UNITED STATES PATENT AND TRADEMARK OFFICE

APPLICATION NO.	FILING DATE	FIRST NAMED INVENTOR	ATTORNEY DOCKET NO.	CONFIRMATION NO.
10/767,634	01/29/2004	Kadri Aygun	TRW(ASG)6925	5396
26294	7590	06/20/2006	EXAMINER	
TAROLLI, SUNDHEIM, COVELL & TUMMINO L.L.P. 1300 EAST NINTH STREET, SUITE 1700 CLEVEVLAND, OH 44114				CULBRETH, ERIC D
ART UNIT		PAPER NUMBER		
3616

Office Action Summary	Application No.	Applicant(s)
	10/767,634	AYGUN ET AL.
	Examiner Eric Culbreth	Art Unit 3616

DETAILED ACTION

Fig. 1a

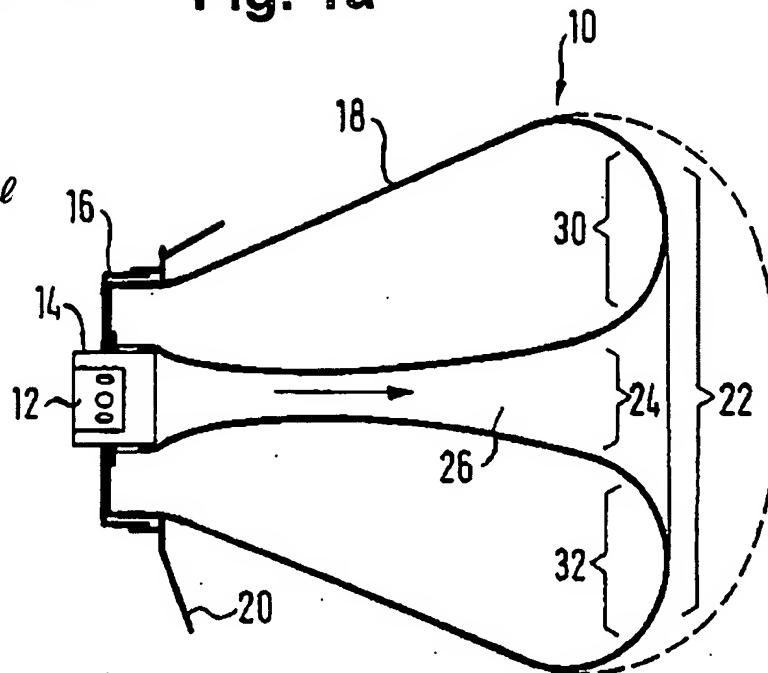
Not
Approved
